Modification to run CPU09CMI on 4.5MHz bus.

On top side:

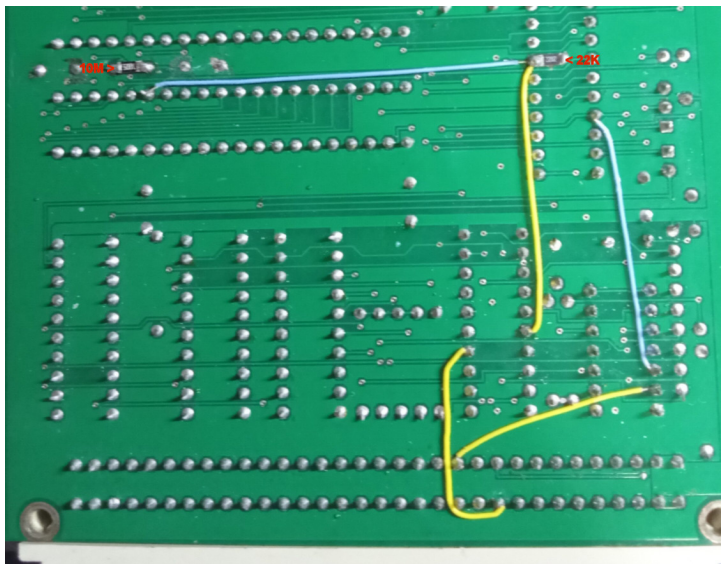
Cut trace between U4-14 and J1 C-21 (B_VMA-)

For REV:0.9 print only cut trace from J1 A23 to R15

On solder side:

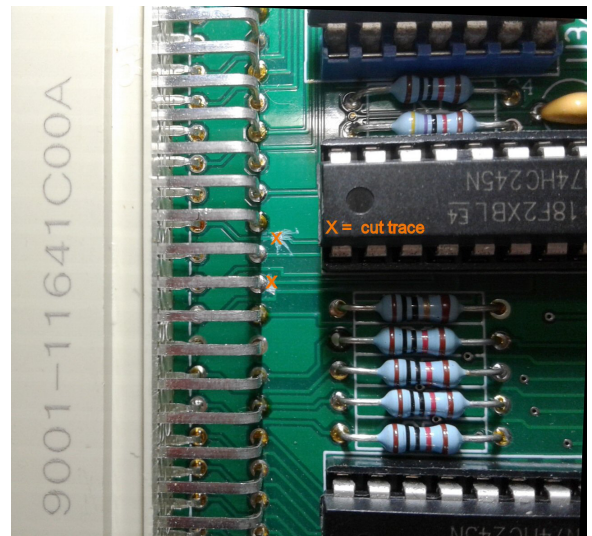
Cut trace between U13-19 and via (OVMA-)

Place 22K resistor between U13-19 and Gnd

Place wire from U6-35 to U13-19 (blue) and U4-6 (Q) (yellow)

Place wire from U4-14 to J1 A-23 (B_Q) (yellow)

Place wire from U3-7 to J1 C-21 (B_VMA-), **Or:**
To keep CPU09CMI 68x02 compatible
or need VMA- signal with 68x02 on the bus
for CPU09GPP or CPU09RAM card.
